Tesla, Inc.
Service Bulletin

Inspect and Rework Front Seat Cushion(s)

SB-26-13-005
June 4, 2026

Figure 1

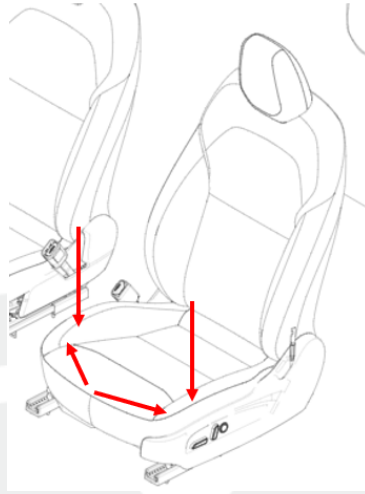
1. Sit in the reported seat and shift weight around, and then press the seat cushion according to the red arrows (Figure 1) to verify if there is a creaking noise from the cushion area.

- If no creaking noise is present, or the noise is not from the cushion area, discontinue this procedure and use Correction Code S012613005.
 - If a creaking noise is heard, coming from the cushion area, continue to the next step to rework the front seat cushion(s).
2. Lift up the reported front seat cushion(s) to gain access to the cushion bottom (refer to Service Manual procedure; [2024+ Model 3](#), [2025+ Model Y](#)).

Figure 2

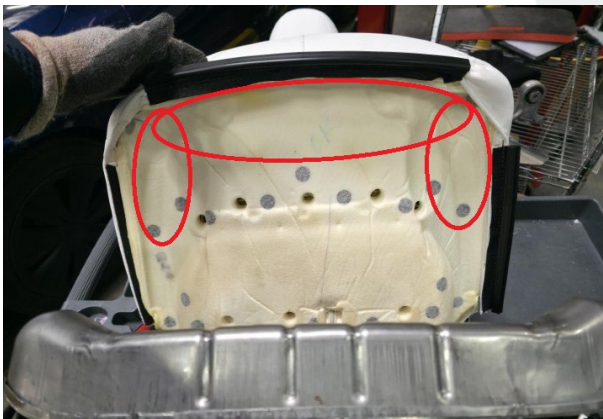
3. Apply felt tape to the outlined area to cover the adhesive residue or friction marks (Figure 2 and 3).

**NOTE:** Overlap the tape if necessary.
